Re: Taco Bell Renovations

4815 4th St NW

Request for Permanent C.O. - Accepted Engineer's Stamp dated: 8-26-15 (F14D071)

Traffic Circulation Layout

TCL-1

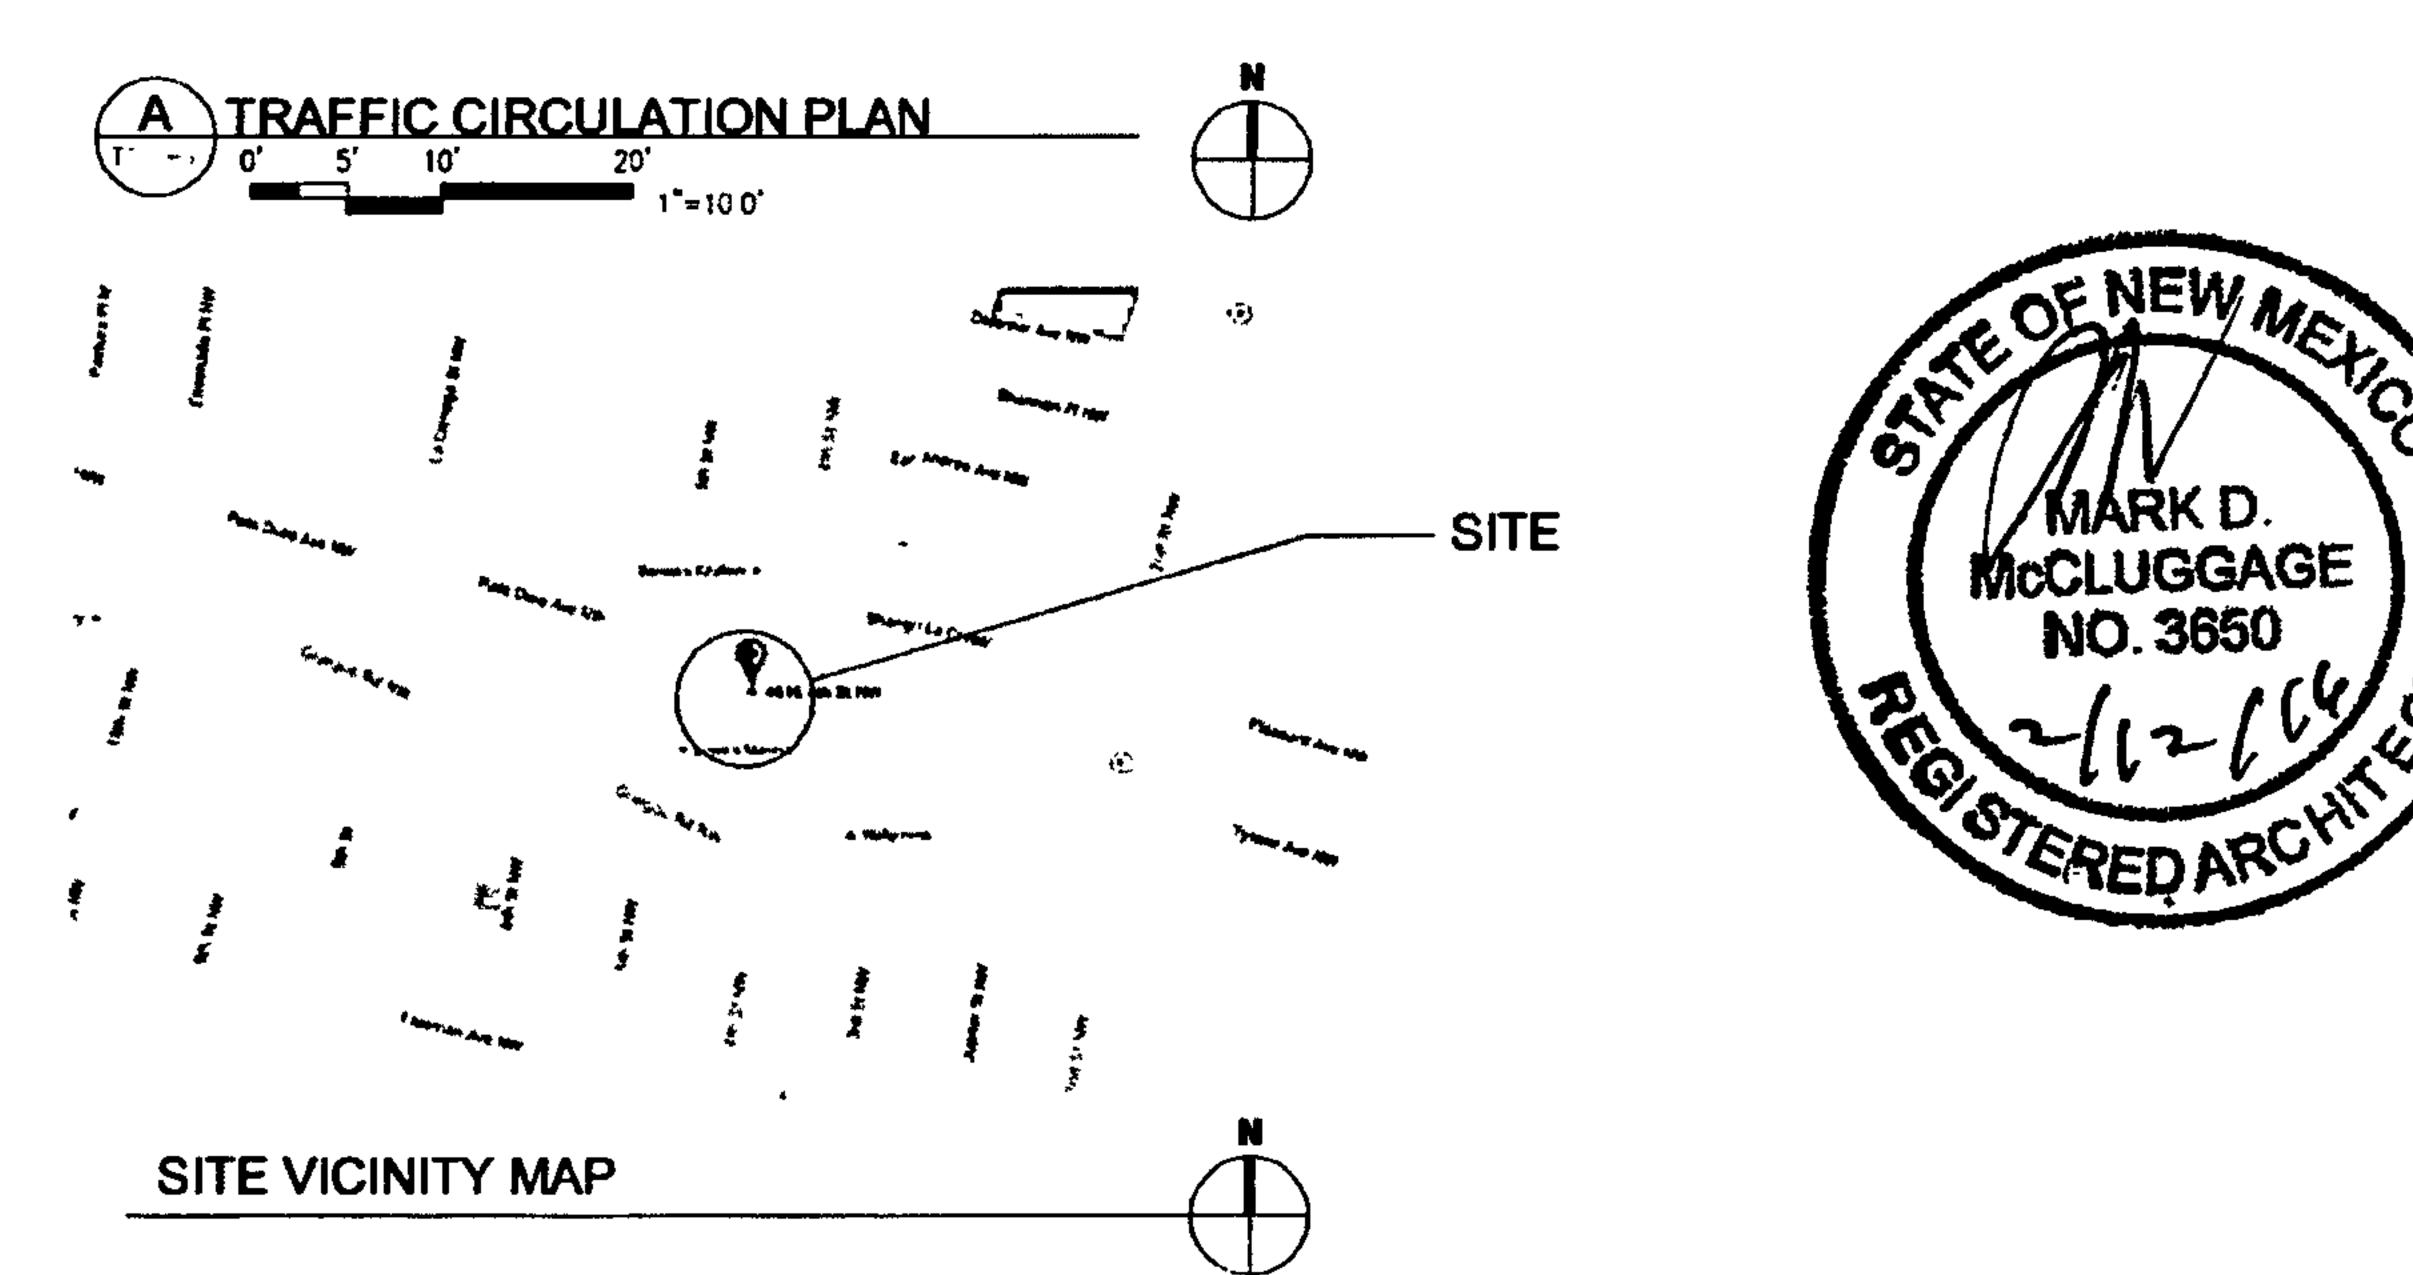
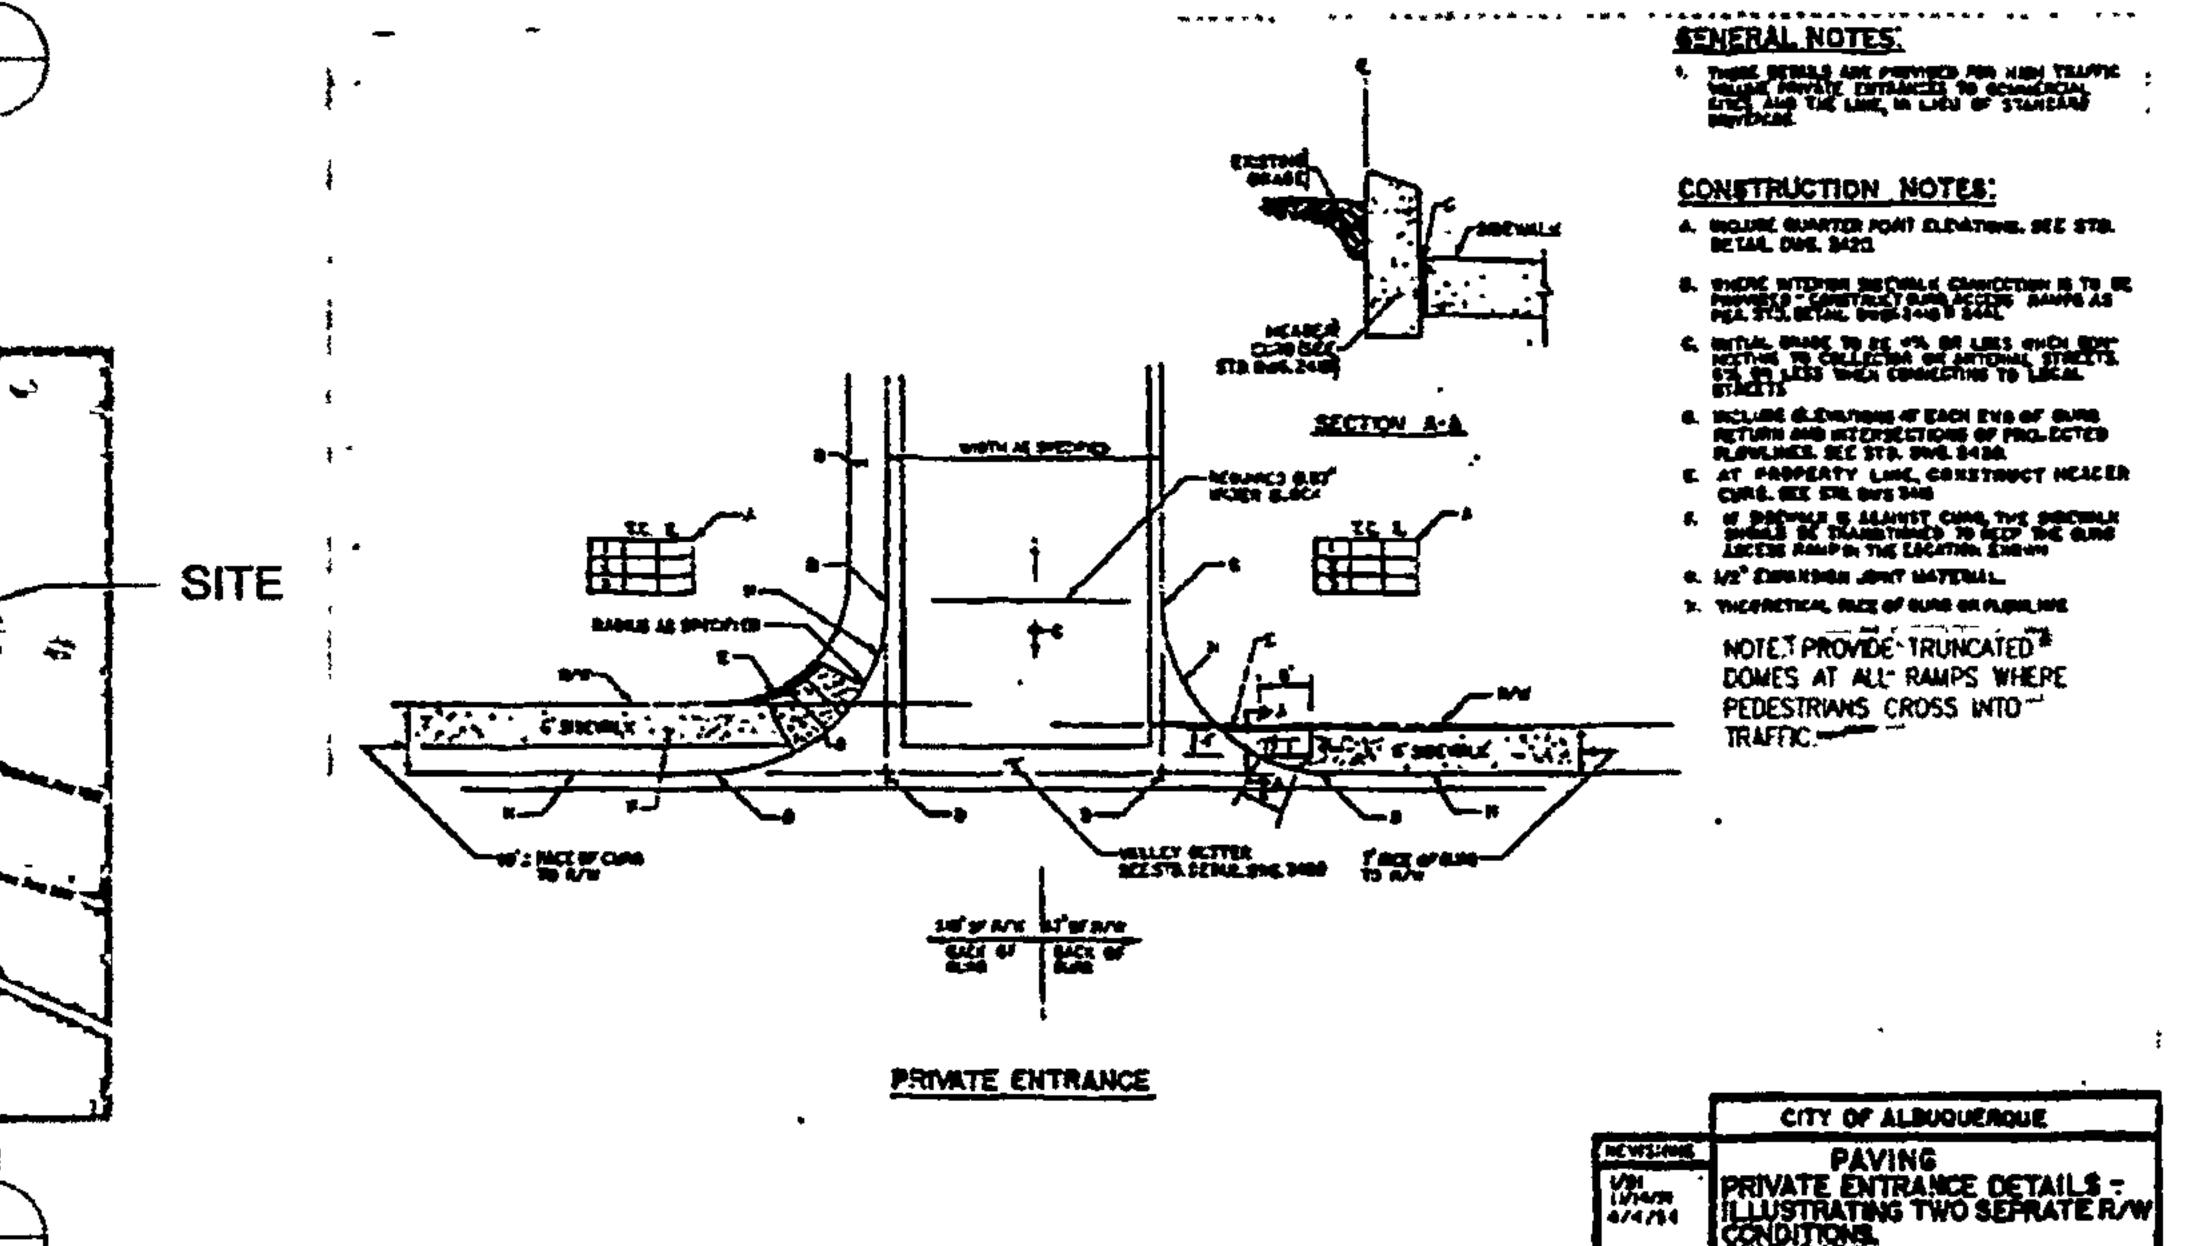
Please show a vicinity map showing the location of the development in relation to streets and well known landmarks.

List the number of parking spaces required by the zoning code as well as the proposed number of parking spaces. Please include the number of required handicap parking spaces.

- 3. Please identify all existing buildings, doors, structures, sidewalks, curbs, drive pads, walls and anything that influences the parking and circulation on the site.
- 4. Identify all existing access easements and rights of way with dimensions.

- 5. Identify the right of way width, medians, curb cuts, and street widths on 4th St. and Palo Duro Ave.
- 6. Please list the width and length for all parking spaces. Detail the overall length of all the diagonal parking spaces and overall drive isle widths.
- 7. Please detail the drive thru queuing length.
- 8. The handicap accessible spaces must include an 8-foot wide van access aisle; all other aisles should be 5 feet in width.
- 9. The ADA accessible parking sign must have the required language per 66-7-352.4C NMSA 1978 "Violators Are Subject to a Fine and/or Towing."
- 10. The ADA access aisle shall have the words "NO PARKING" in capital letters, each of which shall be at least one foot high and at least two inches wide, placed at the rear of the parking space so as to be close to where an adjacent vehicle's rear tire would be placed. (66-1-4.1.B NMSA 1978)

- 11. Per the DPM, a 6 ft. wide ADA accessible pedestrian pathway is required from the public sidewalk to the building entrances. Please clearly show this pathway and provide details from both 4th St. and Palo Duro Ave.
- 12. Per the DPM, a 6 ft. wide ADA accessible pedestrian pathway is required from the HC parking stall access aisles to the building entrances. Please clearly show this pathway from the handicap parking space.
- 13. Service vehicle and/or refuse vehicle maneuvering must be contained on-site; provide a copy of refuse approval.
- 14. Please provide a sight distance exhibit (see the *Development Process Manual*, *Chapter 23, Section 3, Part D.5 Intersection Sight Distance*) for both 4th St. and Palo Duro Ave.

15. Please add the following note to the clear sight triangle: "Landscaping and signage will not interfere with clear sight requirements. Therefore, signs, walls, trees, and shrubbery between 3 and 8 feet tall (as measured from the gutter pan) will not be acceptable in this area."

Response to Comment 1: Vicinity Map has been added to the Plan.

Response to Comment 2: Parking requirements and numbers have been added to the Plan.

Response to Comment 3: Additional notes identifying various structures have been added to the Plan.

Response to Comment 4: There are not access easements on the property. Dimensions showing distances from the property line to the street curbs have been added to the Plan.

Response to Comment 5: Additional dimensions have been added to the Plan.

Response to Comment 6: Dimensions of the parking stalls are shown on the Plan. All standard stalls shall be 18 feet long by 9 feet wide.

Response to Comment 7: Seven car stack at the drive-thru has been illustrated on the Plan

Response to Comment 8: An 8'-o" wide ADA access aisle has been added to the Plan.

Response to Comment 9: ADA parking sign detail and required language for the sign have been added to the Plan.

Response to Comment 10: The required "NO PARKING" painted lettering within the ADA access aisle has been added to the Plan.

Response to Comment 11: A 6'-0" wide sidewalk connect the ADA access aisle and the sidewalk along Palo Duro Avenue has been added to the Plan. Sidewalk and ramps connecting to 4th Street has been widened to 6'-0"

Response to Comment 12: The crosswalk striping from the ADA parking aisle to the ADA ramp at the building has been widened to 6'-o".

Response to Comment 14: A 35-foot clear site distance triangle has been added to the Plan.

Response to Comment 15: The required clear site triangle language has been added to the Plan.
